**MINUTES
PLANNING COMMISSION
CITY OF LAKEWOOD
12650 DETROIT AVENUE
AUDITORIUM
OCTOBER 5, 2023
6:30 P.M.
RECORDED
<https://www.lakewoodoh.gov/videos-2/>**

- 1. Docket No. 10-21-23
14824-6/14806-22 Detroit Ave.
CoHatch**

**LOT SPLIT & CONSOLIDATION
COHATCH / FIRST FEDERAL OF LAKEWOOD**

LEGAL DESCRIPTION and PLAT REVIEW COMMENTS

Proposed Plat

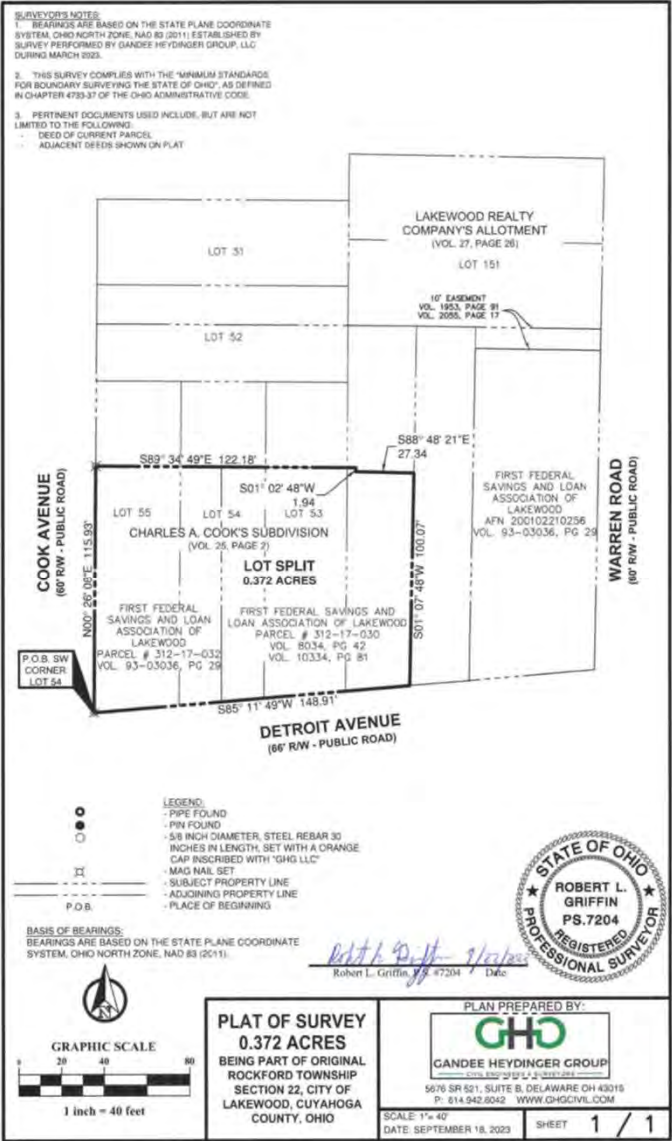
- Legal Description Comments:
 - Need a Principal Point of Beginning that begins at a published/recorded monument with description. You can not use a set point to begin your commencement.

- The third call is incorrect it should be South 01 Degree 02 Minutes 48 Seconds
 - Need to state in a separate paragraph the intent of the split
 - Need to state what type pins are being set and cap.

- Need to call out what monumentation is to be set either an Iron pin with cap or another acceptable monument per the ORC. A "point" is not an acceptable corner.

- Specify the acreage for each parcel that is going to be affected by the split and the residual acreage.
- Plat of Consolidation
 - Non-Compliant, you cannot use an ALTA survey to consolidate these parcels of land. The consolidation plat either needs to be on a separate plat of survey showing the required information per the ORC and monumentation. Or you can show the consolidation plat on the Lot Split Plat of 0.372 Acres

- Plat of Survey for the 0.372 Acres Lot Split
 - Need to show adjoiners on the plat and label the Permanent Parcel Number, Instrument Number, and Acreage

- Show the original Lot Lines of the Charles A Cook's Subdivision and Lakewood Realty Company's allotment.
- Need to indicate what monuments were found and used.
- Need to call out what monuments are going to be set at least along the right of way.
- Area of Tabulation of what is going to the consolidated, split, total acreage.
- Need to show monumentation used to establish Detroit Ave., Warren Rd., and Cook Avenue and the Right of Way.
- Need to include a Principal Point of Beginning that tie to a published/recorded monument.
- Need to show tie lines to monumentation being set
- Need to state record or measured or calculated distances.
- Note what the intent is for the split and consolidation.
- State whether the buildings are online, encroaching or clear of the property line.

1. The comments provided by the City Engineer via CT Consultants dated October 4, 2023, must be addressed to the satisfaction of the City Engineer and revised documents submitted for signature and recording.

Required Parking

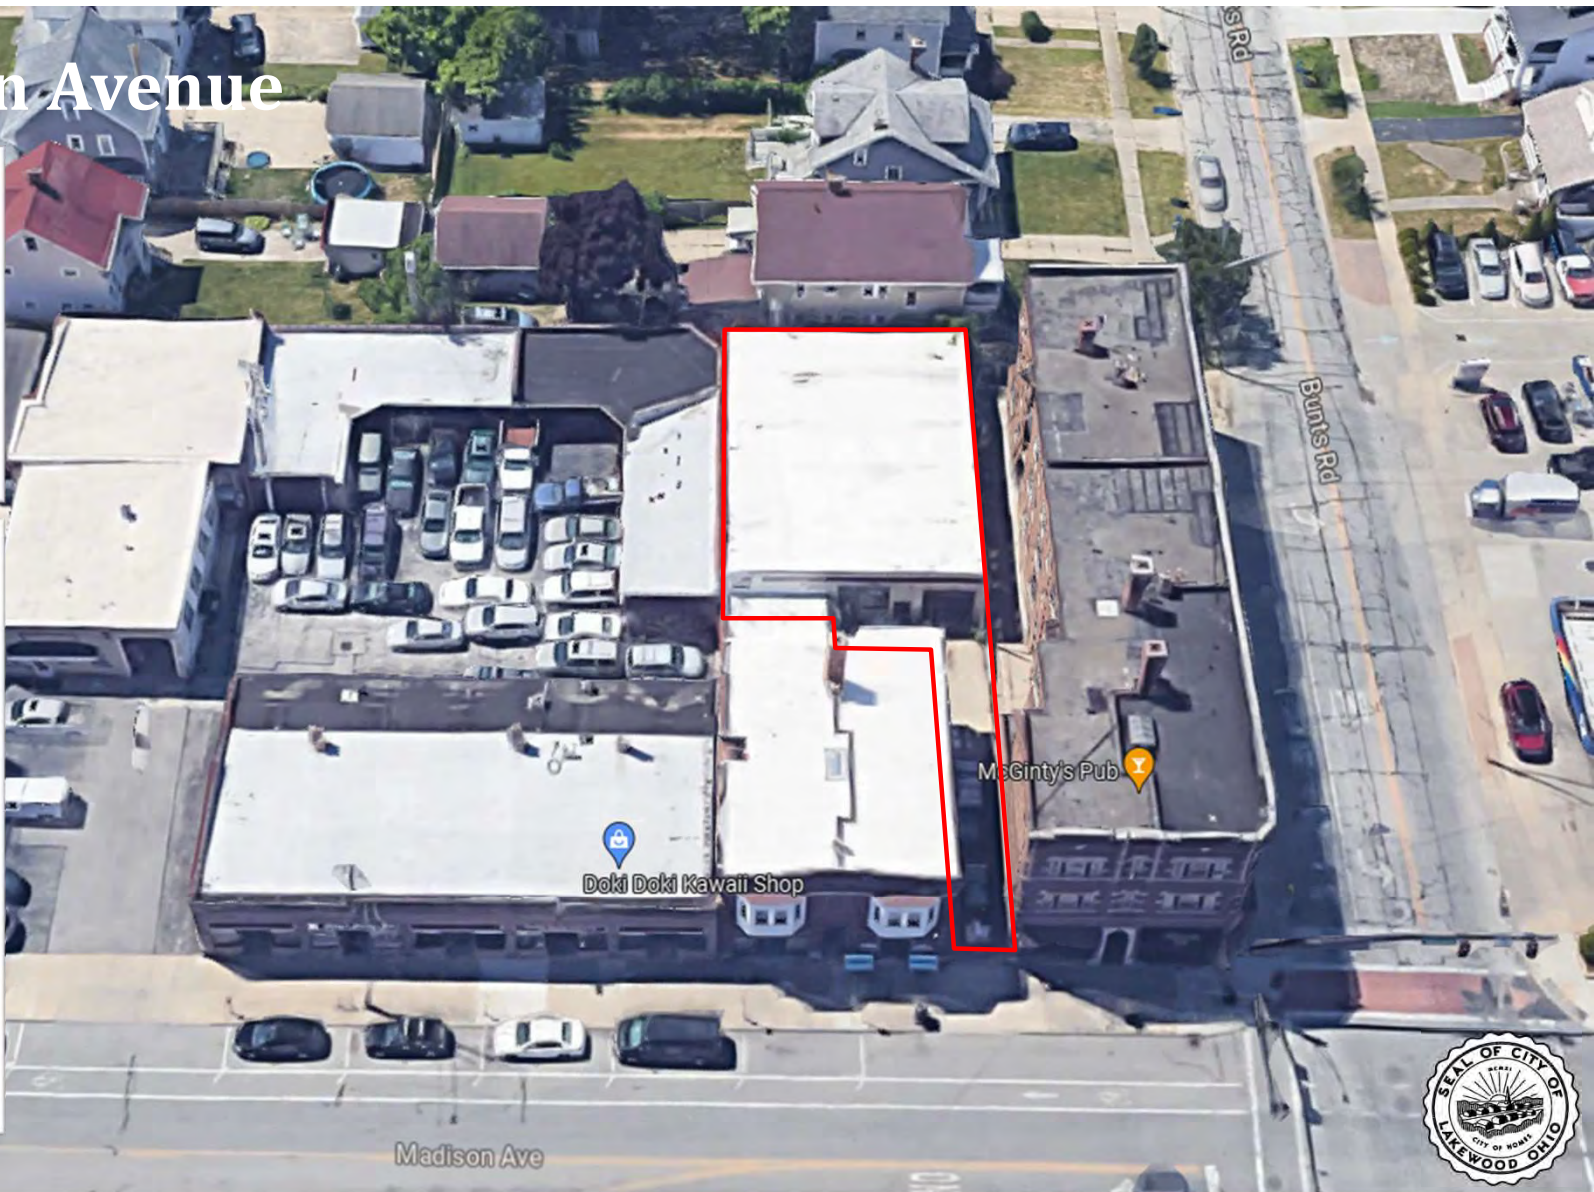
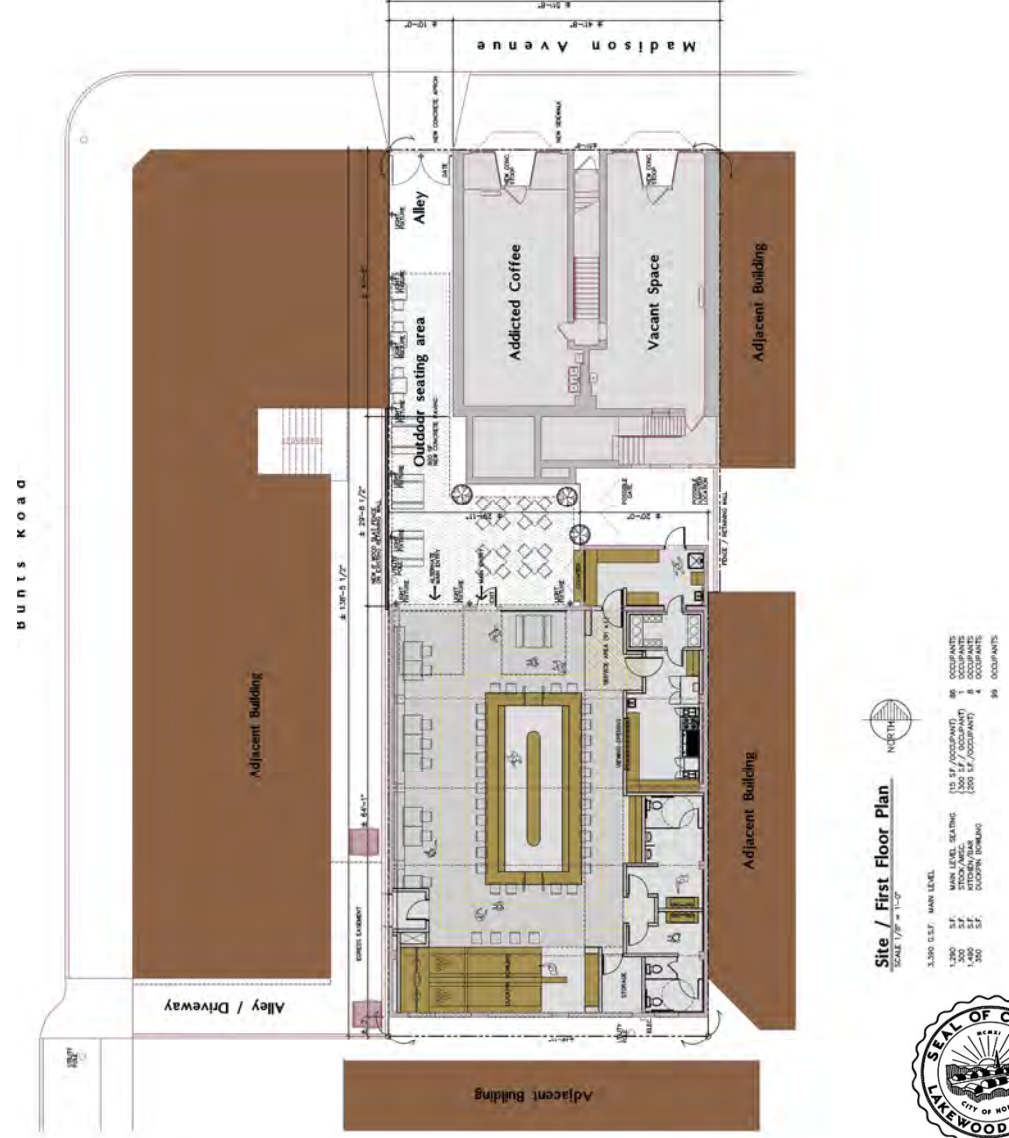
1. Confirm the square footage area of the outdoor dining area.
2. Provide additional off-site, off-street parking as required by the Zoning Code for the outdoor dining area.
3. Clearly delineate the off-site, off-street parking spaces and mark them for use by this business.
4. Design one of the off-street parking spaces to meet ADA requirements.
5. Clarify the provision of refuse service for the site and how it impacts the outdoor dining area.
6. Provide a full screen and gate for the refuse containers for review and approval by the Architectural Board of Review.
7. Clarify how access and accessibility are maintained given the existing retaining walls and proposed fences on the east and west sides of the property.
